PLANNING COMMISSION
Regular Meeting
Monday, August 7, 2017
7:00 PM
Christine Nuernberg Hall

Agenda

TO: Planning Commission
FROM: JAC ZADER, ASSISTANT DIRECTOR COMMUNITY DEVELOPMENT
DATE: August 4, 2017
SUBJECT: Raposa Design for Brixmor SPE I LLC. The applicant is seeking conditional use grant amendment approval to allow for an expansion to the outdoor dining patio at 11046 N. Port Washington Road (Chancery).

L-3

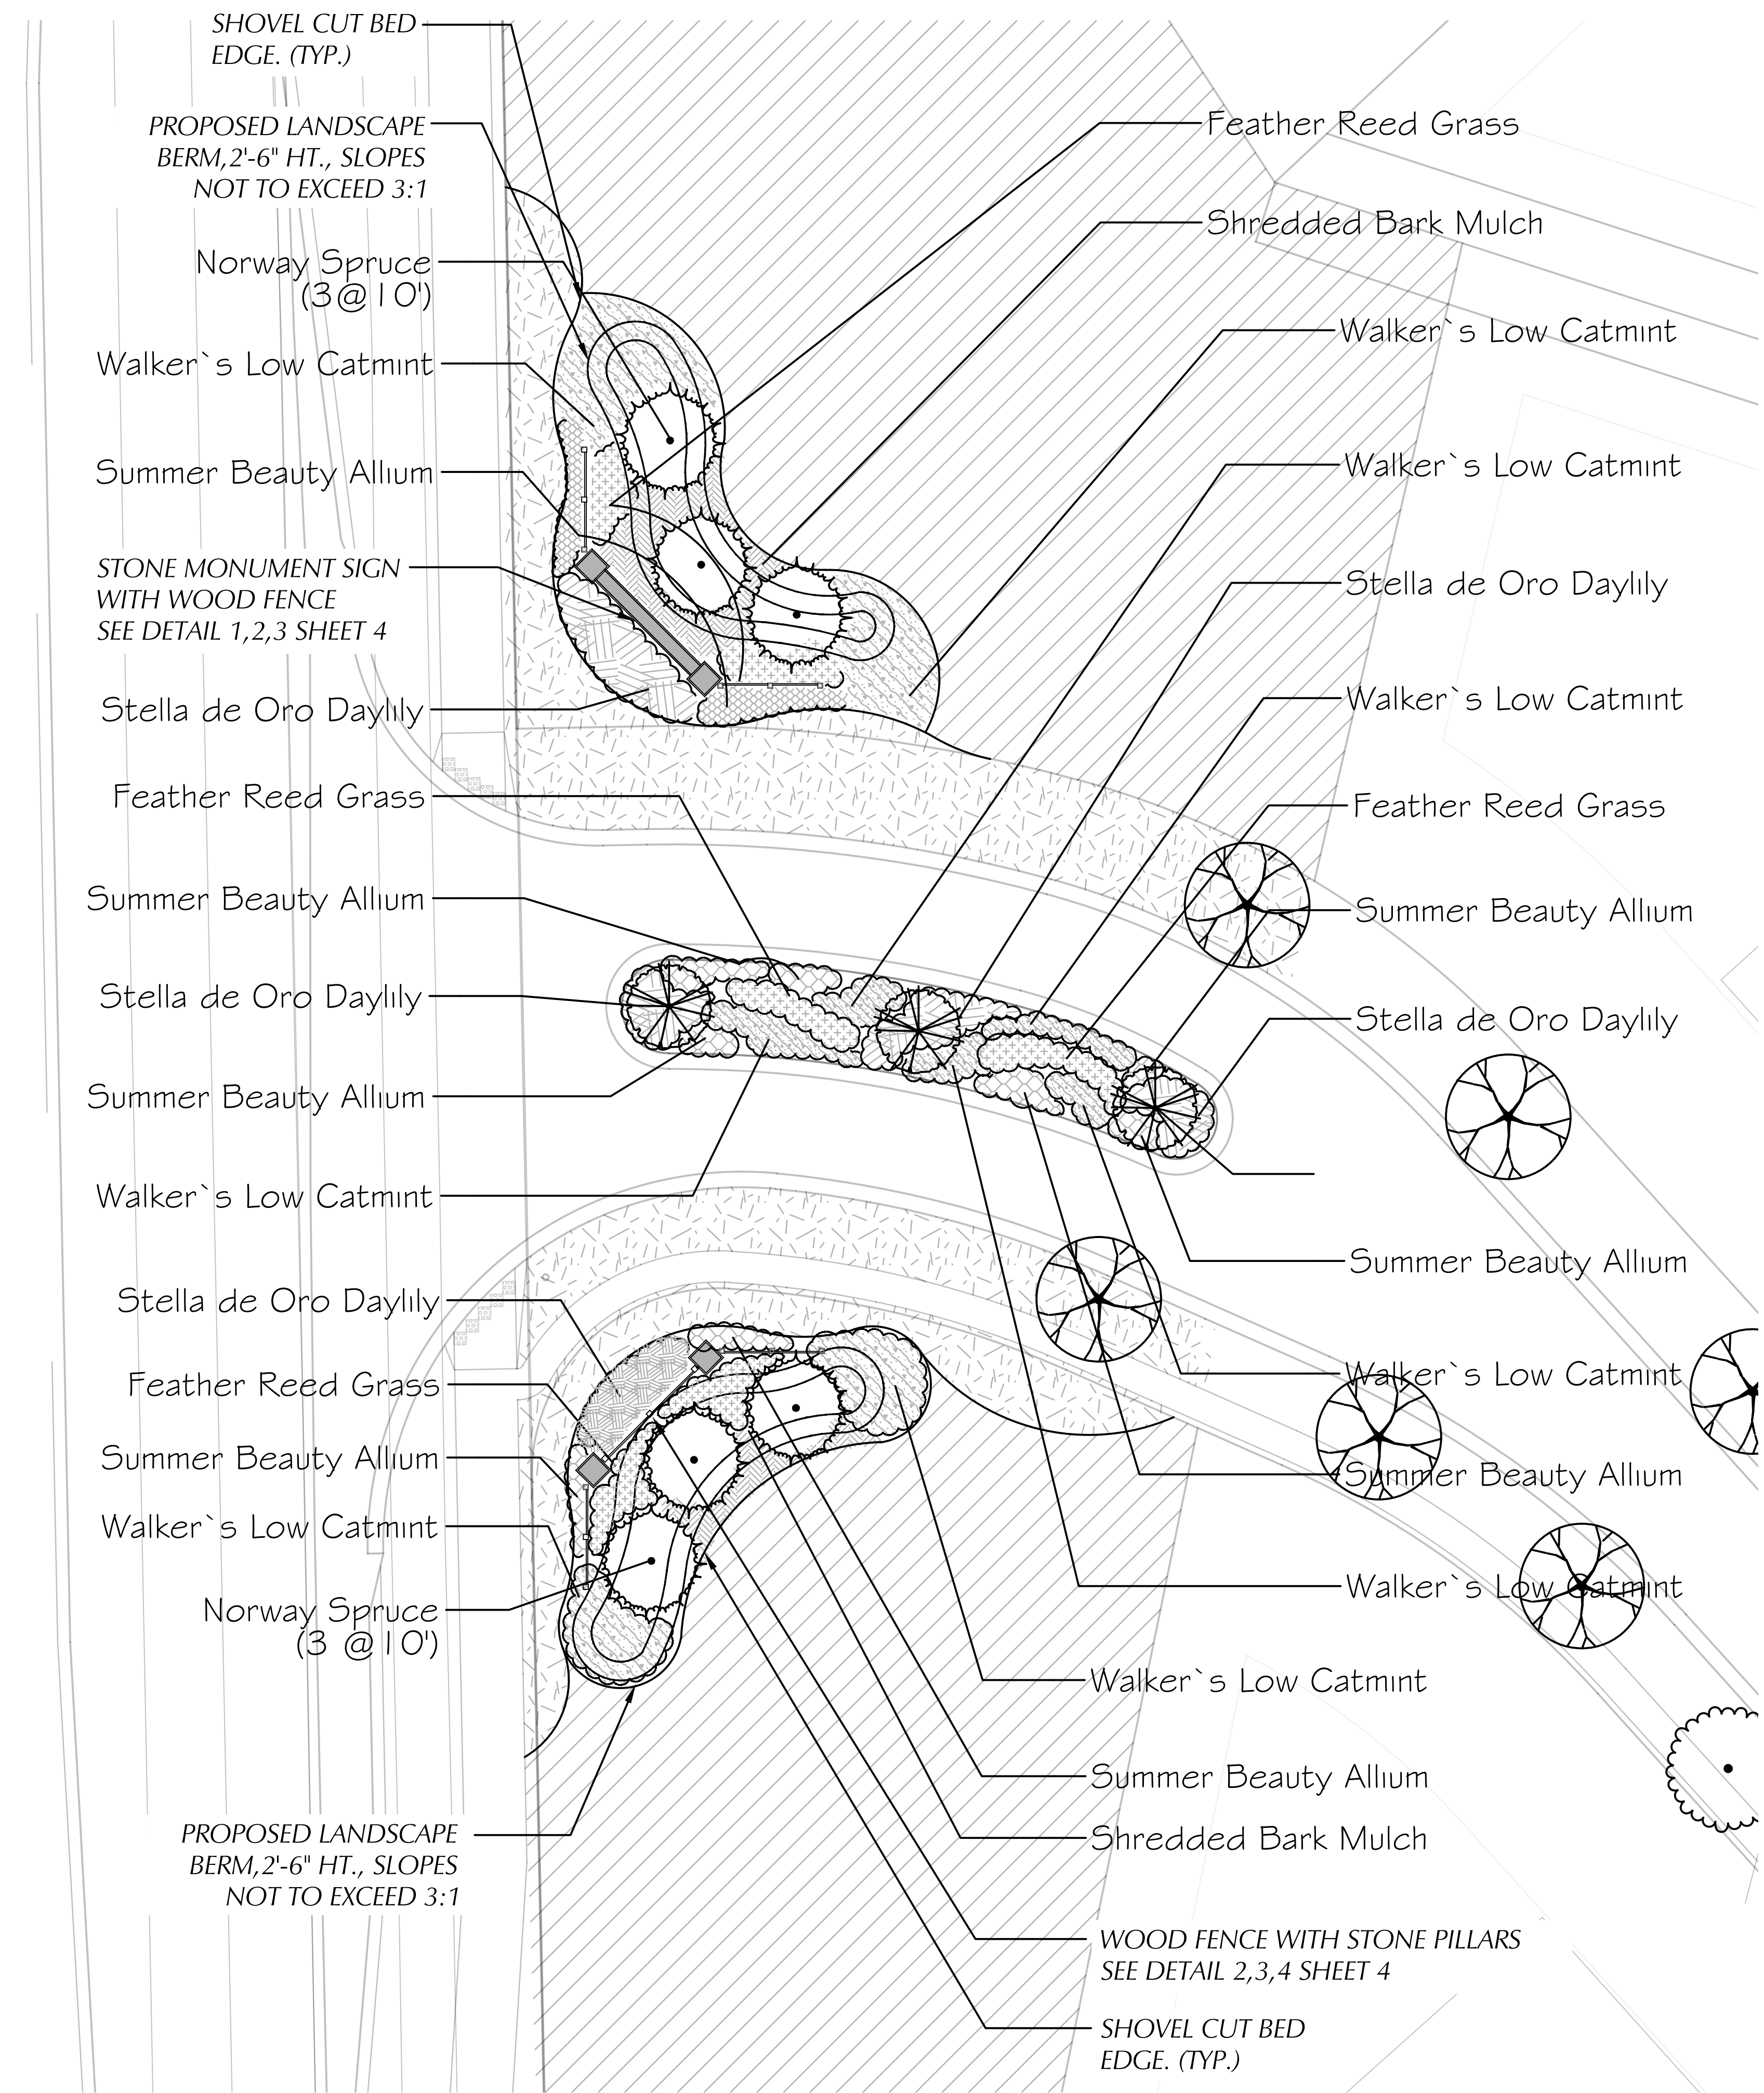
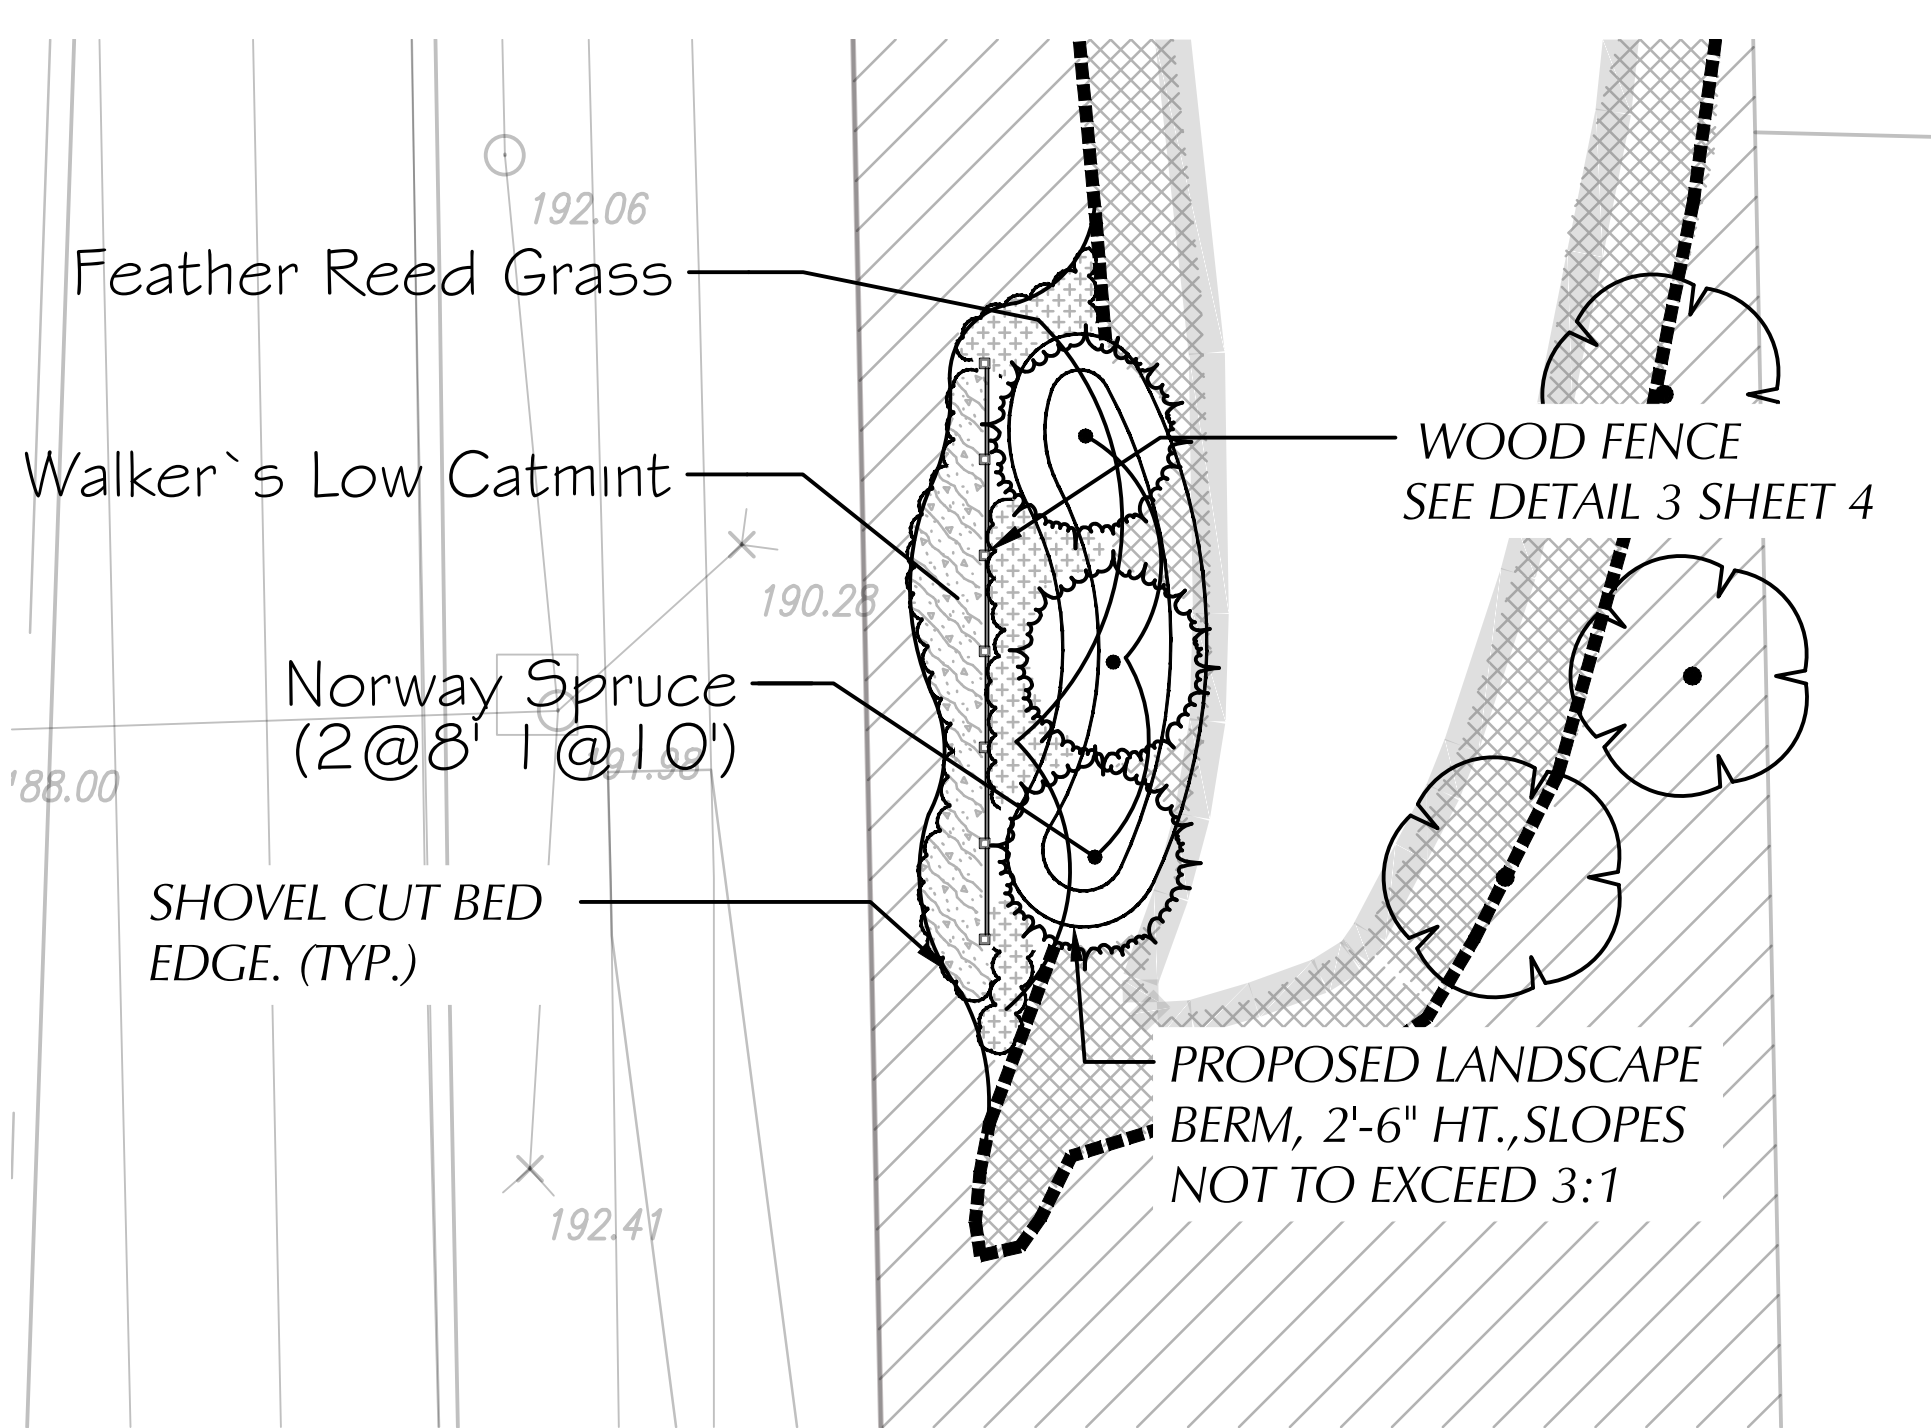
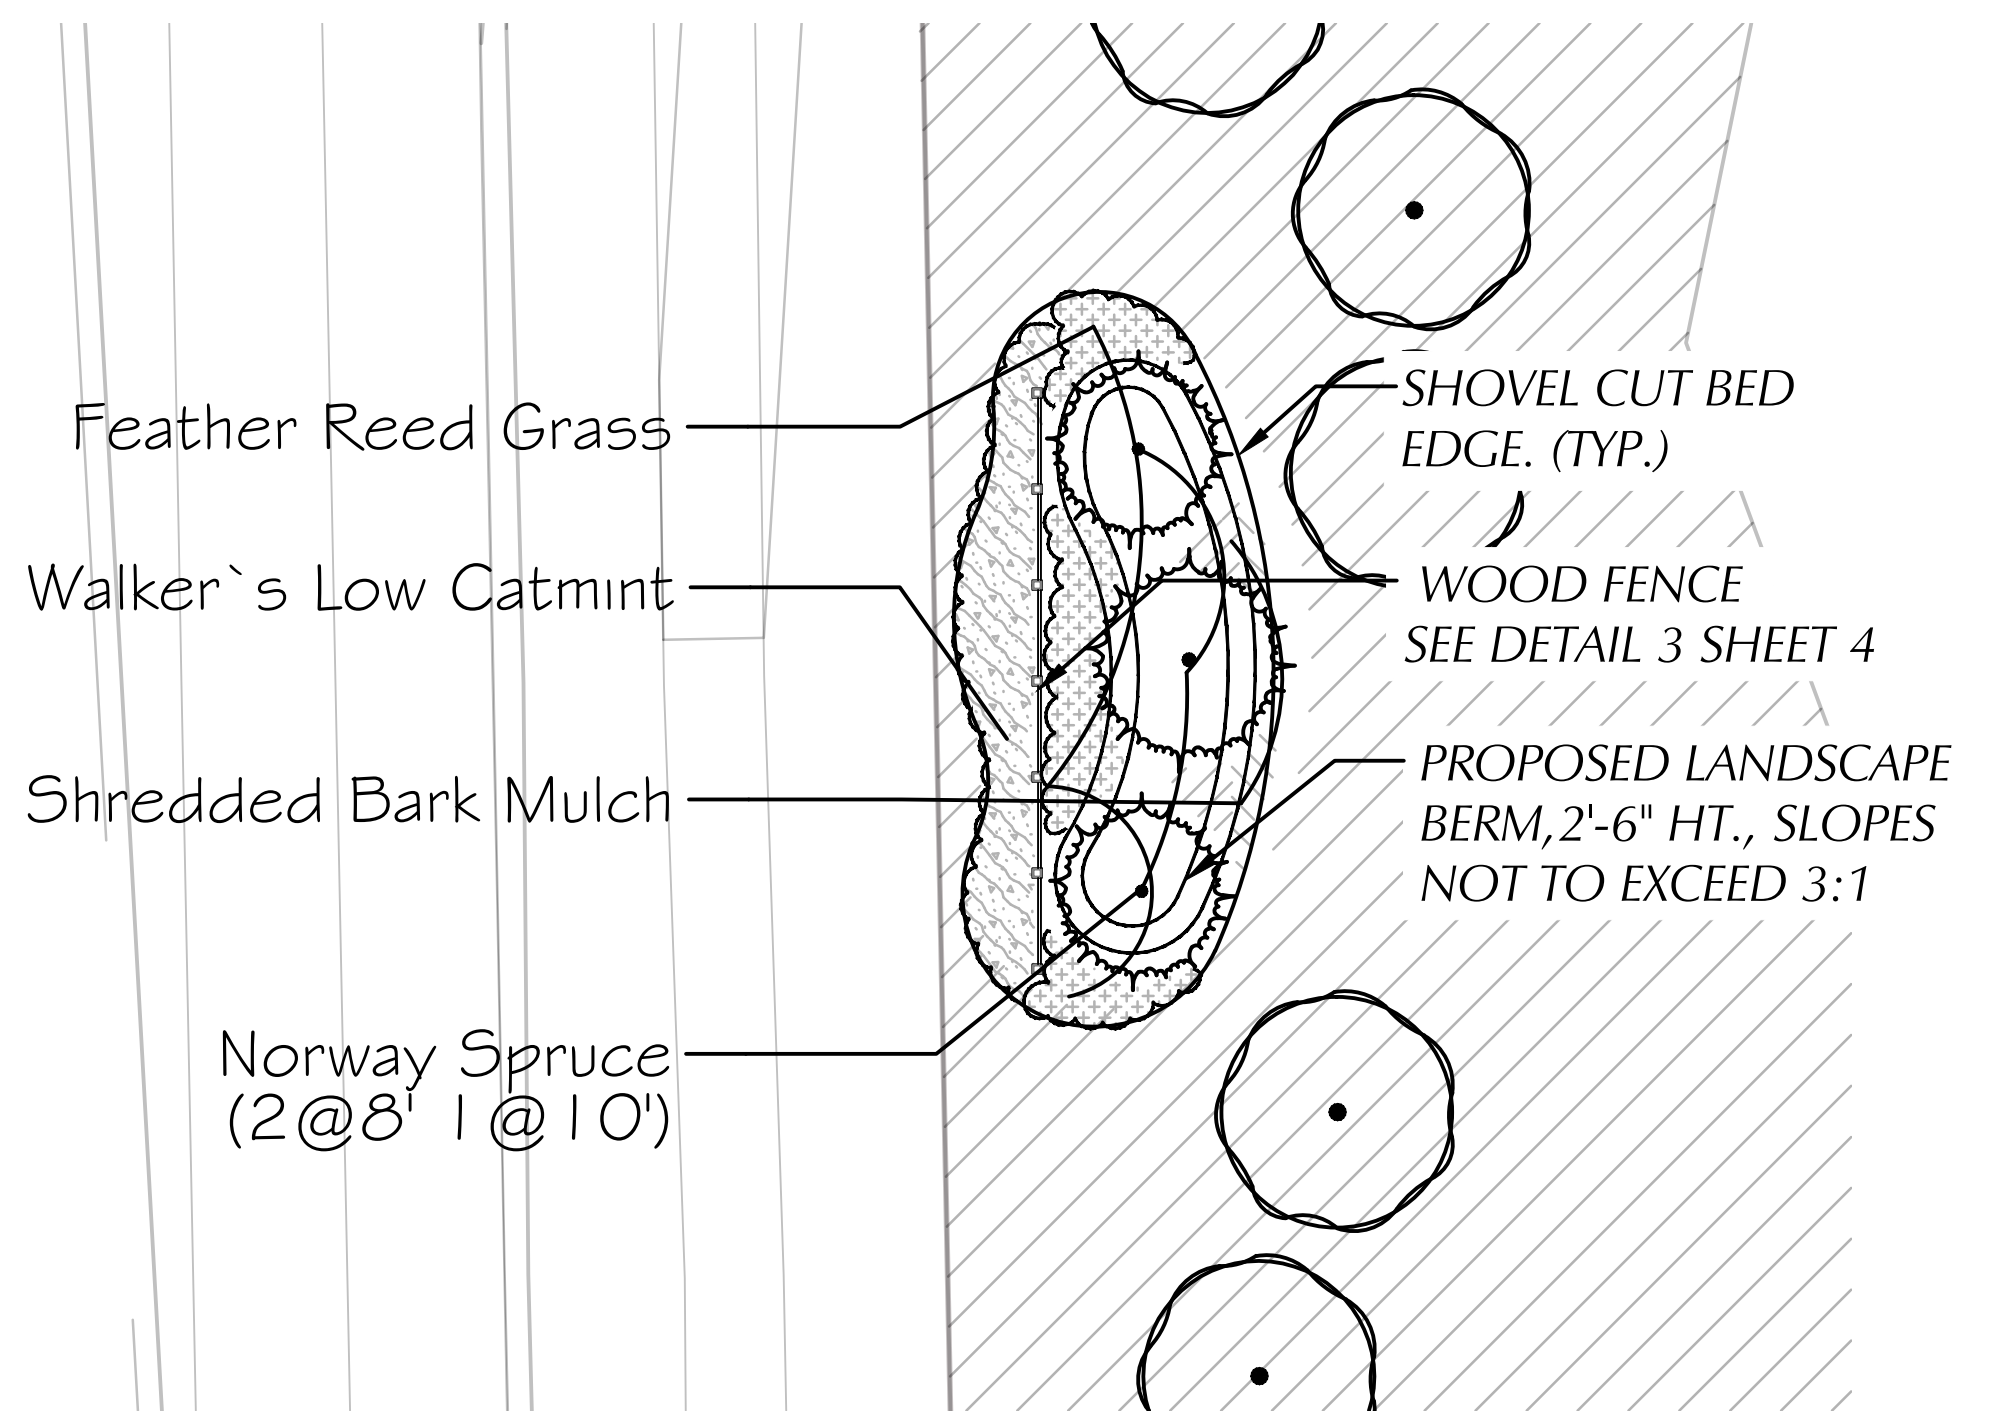
The perennial plantings and the ornamental grass rate applications cannot be determined. The plan fail to specify the arrangement: linear w/12” planting, random, OR On Center. The detail blow up provided on sheet L-3 fails to assign the number of Perennial plantings will be used in each designated area. Amend plan/details to include the planting arrangement, spacing and # of plantings per each zone shown.
